OXFORDSHIRE COUNTY COUNCIL'S RESPONSE TO CONSULTATION ON THE FOLLOWING DEVELOPMENT PROPOSAL

Application no: 21/02339/REM

Proposal: Reserved Matters application for 14/02121/OUT, Phase 1 Development of 500 dwellings, landscaping, new vehicular, cycle and pedestrian access routes and other operations

Location: Proposed Himley Village North West Bicester, Middleton Stoney Road, Bicester

Access and circulation

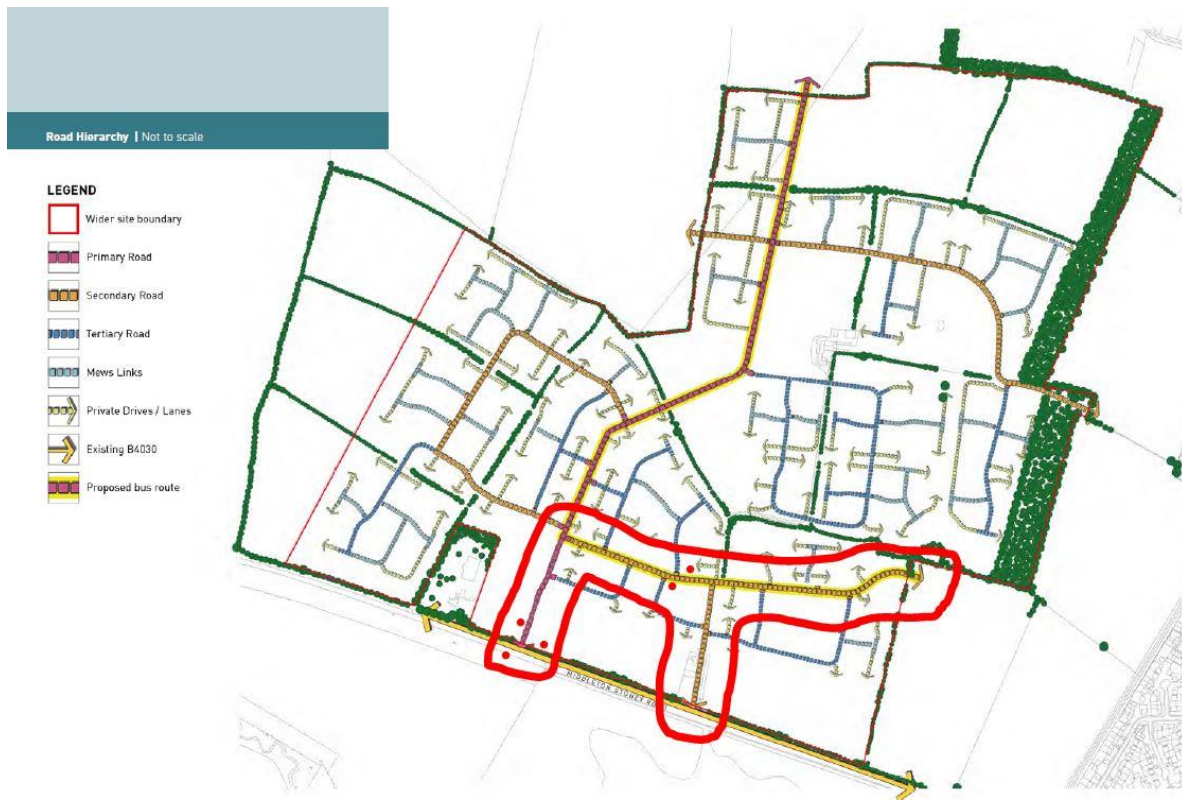
time. It is therefore imperative that an initial bus route can penetrate into the Phase 1 development at an early stage. Therefore the roads indicated in the above diagram (circled with red lines) must be to Primary standards, not Secondary, as two-way bus operation will almost certainly be required on these streets for a significant period. (from p109 of Design Code).

practice. Bus stops (five in total) must be delivered as indicated by the red dots on the above plan, which will enable access to the development both before and after the route through the development is available. A pair of stops must also be provided on the link road between the two access points, in the centre of the proposed Phase 1 development. It is imperative that bus access through the development must be available at the earliest opportunity and certainly no later than occupation of 220 dwellings.
